POLICY REPORT
DEVELOPMENT AND BUILDING

Report Date: May 31, 2016
Contact: Susan Haid
Contact No.: 604.871.6431
RTS No.: 11486
VanRIMS No.: 08-2000-20
Meeting Date: June 14, 2016

TO: Vancouver City Council
FROM: Acting General Manager of Planning and Development Services
SUBJECT: CD-1 Rezoning: 7807 Cambie Street

Figure 2: Site Plan

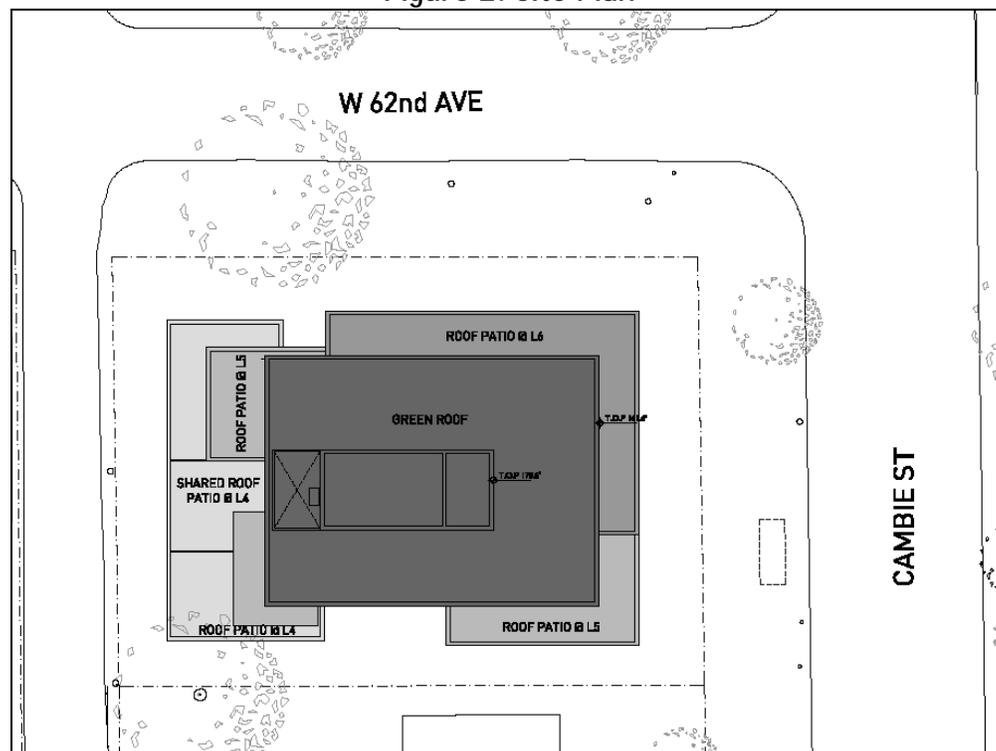
- 1. Design development to better transition between the proposed building massing and properties to the west.
 - (i) Reduce the portion of the building at level four that encroaches into the 9.0 m (30 ft.) rear yard setback from 3.6 m (12 ft.) to 2.4 m (8 ft.).
 - (ii) Delete the wraparound balcony at the southwest building corner from level four and up. Consider a 'springboard' balcony configuration along the south elevation.
- 2. Design development to reduce building height and density.

Note to Applicant: Relocate rooftop mechanical room to parking level and reconfigure elevator penthouse/roof access to comply with Section 10.11.1 of the Zoning and Development By-law so as not to increase density or height.
- 3. Design development to enhance interface with the public realm.
 - (i) Introduce larger window openings or greater number of these to west concrete wall to animate interface with the lane.
 - (ii) Ensure brick cladding on surface reveal surrounding parking entry, to reduce area of concrete wall facing the lane.
 - (iii) Introduce a raised planter wall to the northwest corner, to accommodate feature planting at the head of the lane and screen the pad mounted transformer (PMT).

- (vii) Provision of a 20 ft. wide ramp as 19.5 ft. is shown on drawing A3.01;

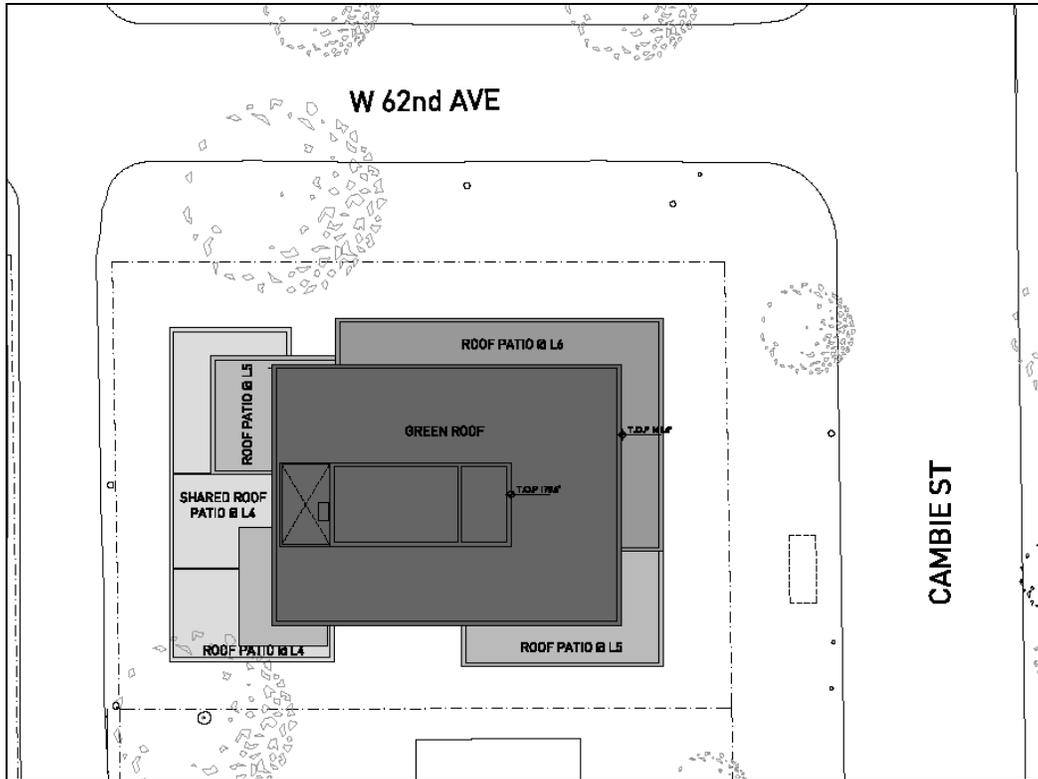
There is some worry about the window wall on top in terms of materiality and the perception of overlook from all the glass. The glass box is also the worst thing to do from a sustainability standpoint. There is not enough rationale for this aspect of the project.

If the exposed concrete is part of the floor slab then it is creating an enormous thermal bridge. Thought needs to be given to how to insulate this area effectively.

Applicant's Response: The applicant team had no further comments.
